MEMORANDUM

SUBJECT: Revisions to Draft RI Figures
ICS Remedial Investigation Report – February 2020

ICS/NW Cooperage Site
Seattle, Washington

FIGURE
4-19a

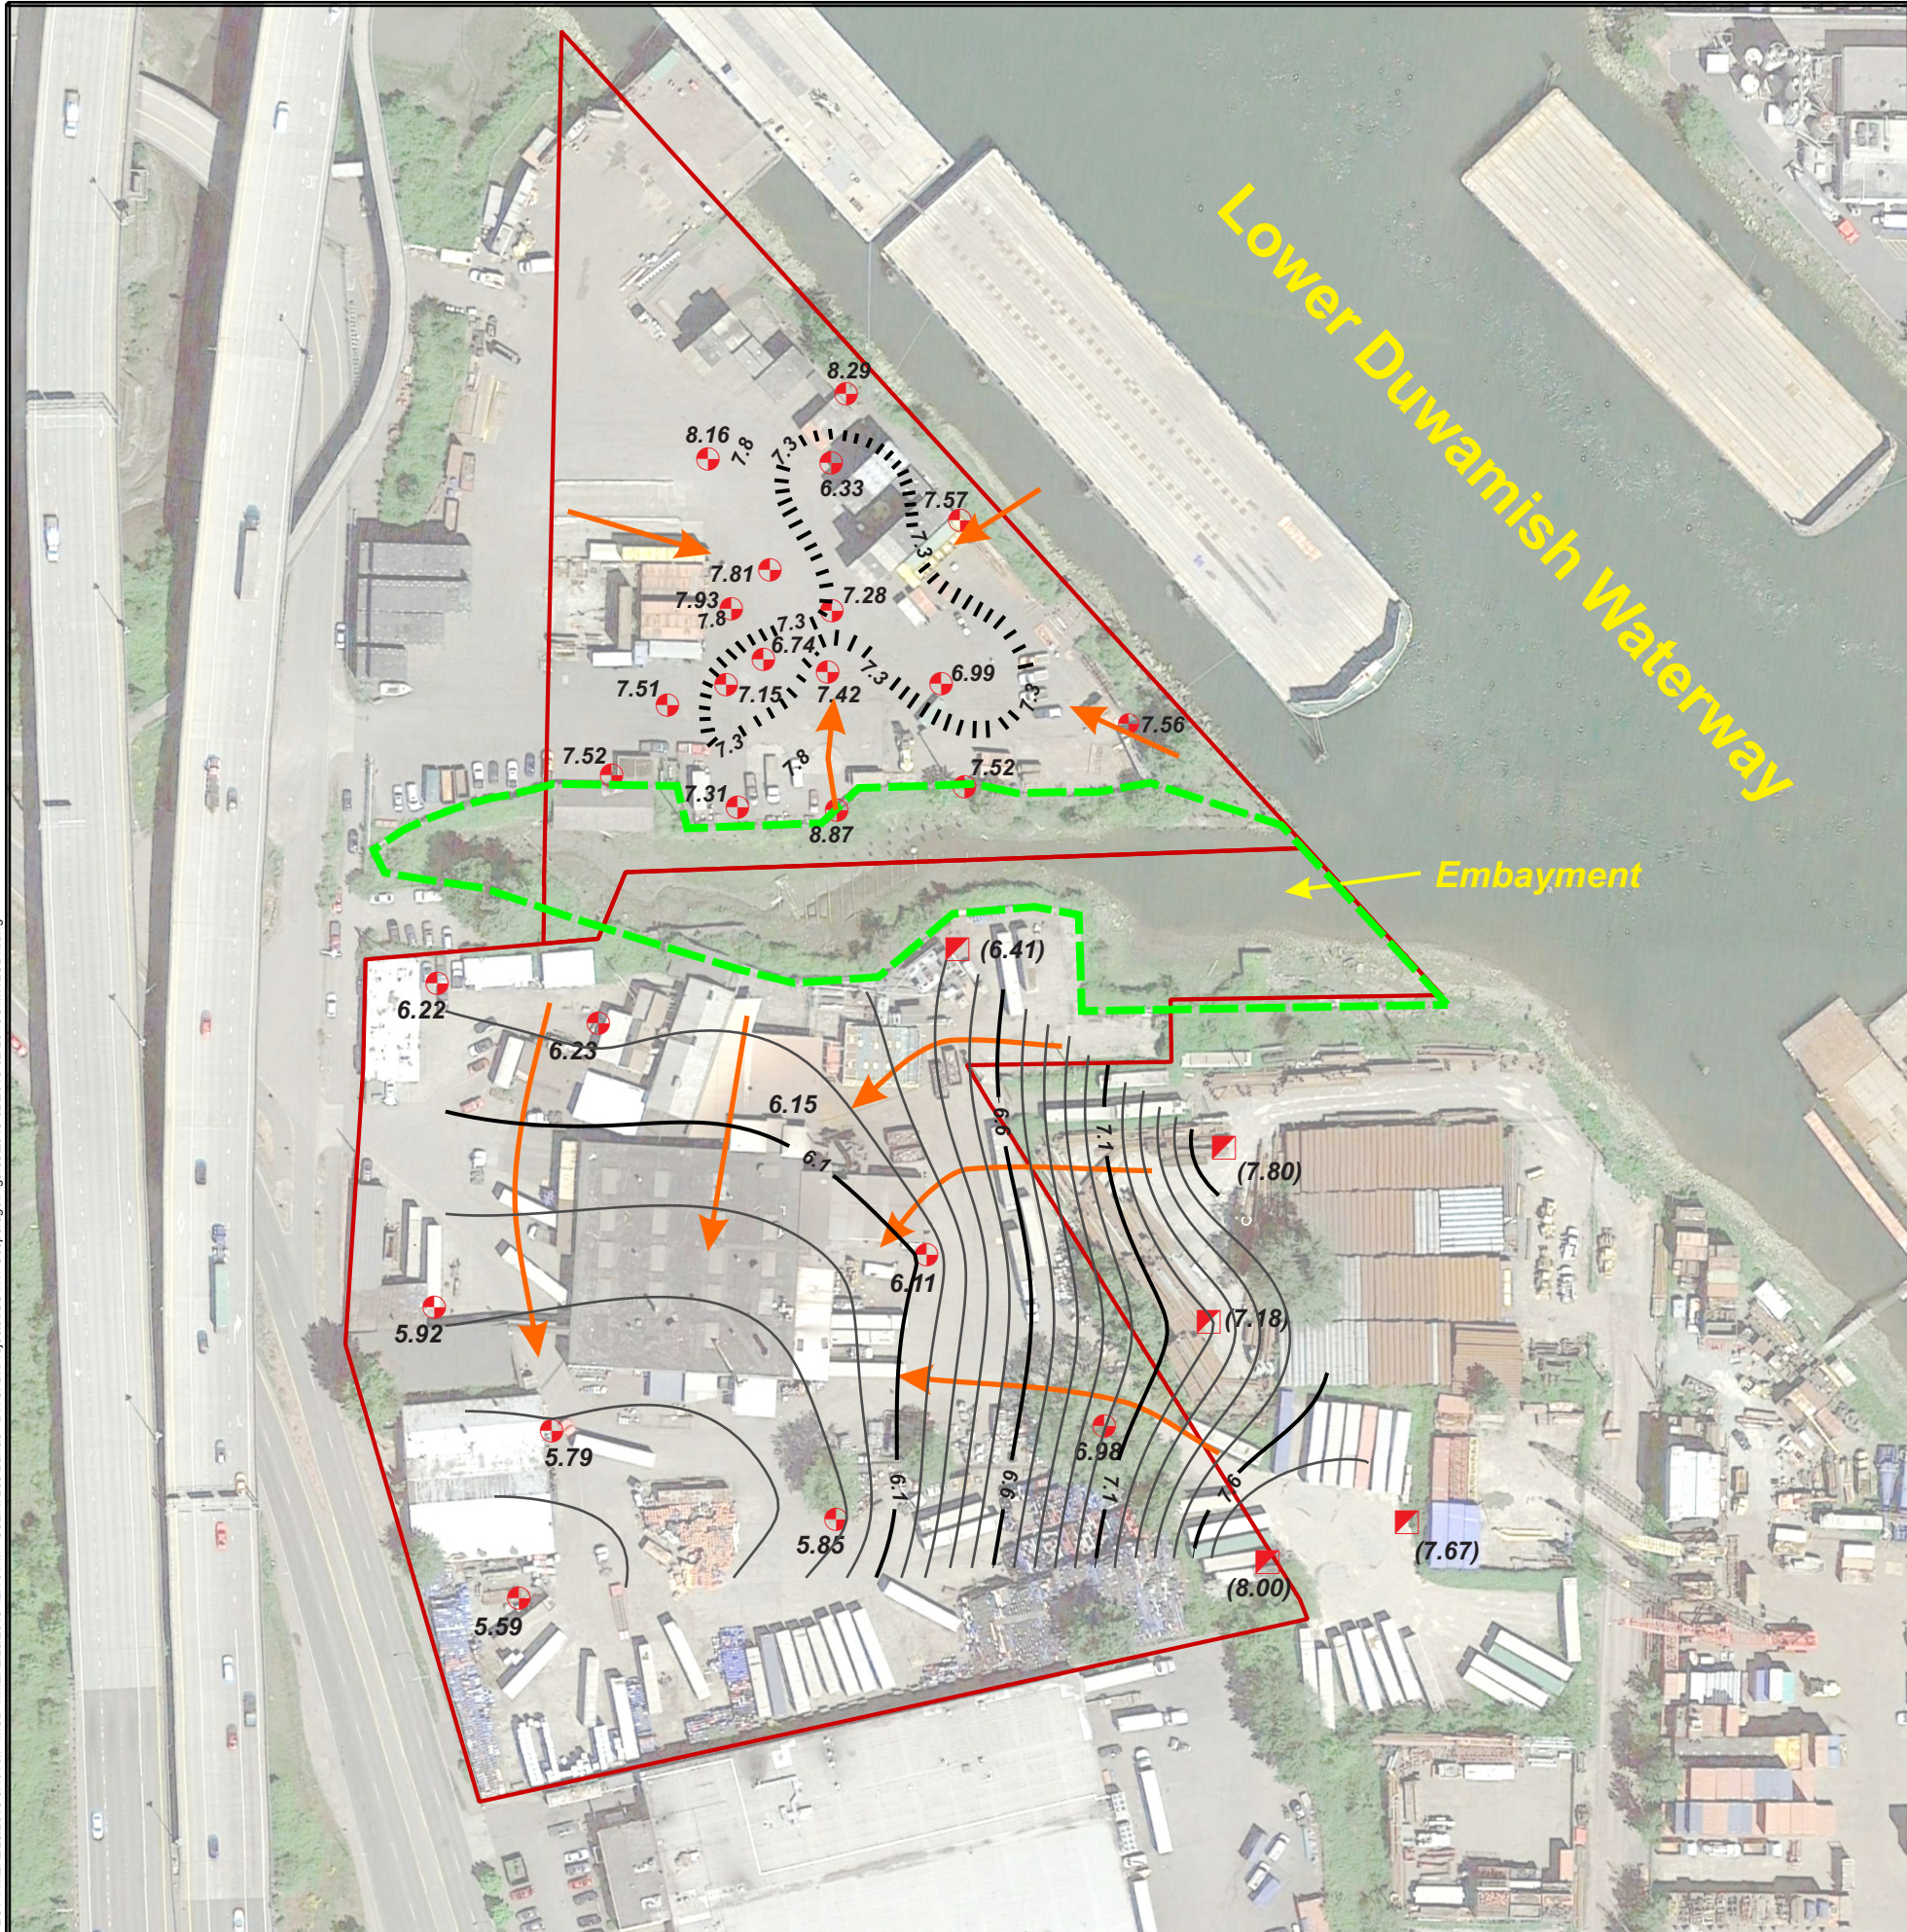
REVISIONS TO FIGURES 4-19a and 4-19b

Figures 4-19a and 4-19b illustrate groundwater flow directions in the Upper Zone that lies between the Water Table Zone and the Deeper Zone. Wells that are screened in each of these zones are shown on draft RI Figures 4-12a,b,c. As shown on these figures, there are no Upper Zone wells located east of the former settling lagoon and flow directions were estimated without benefit of water level elevation data east of the ICS upland property as requested by Ecology. While the high tide flow direction estimates appear reasonable (flow inward to the property), low tide flow directions do not appear representative based on the estimated flow directions using data collected in 2016 (Figure 4-17b in the draft RI), the magnitude of the water level changes

Upper zone water level elevations at any given location would be expected to lie between those measured in Water Table wells and those measured in Lower Zone wells to correct for vertical gradients. The high and low tide monitoring well water-level elevations calculated using data collected in February 2018 are summarized in Attached Table A4.3 of the draft RI. Elevations for high and low tide conditions for Water Table and Lower Zone wells east of the property are summarized in Tables 1 and 2 below.

The estimated Upper Zone water level elevations (Tables 1 and 2) were combined with the Upper Zone elevations from wells located on the ICS upland property to prepare water level elevation contour maps to estimate groundwater flow gradients. The revised contour maps (Figures 4-19a and 4-19b) are attached.

The revised high tide flow gradients are similar to those estimated in the February 2020 draft RI and show that the gradients are inward to the property. The east well high tide elevations did not significantly change the flow gradient patterns. However, using the estimated low tide Upper Zone water level elevations, the gradients beneath the western portions of the site are towards the head of the embayment, while those beneath the eastern portion of the site are in an easterly direction towards the LDW. A ground water divide separates the two areas.
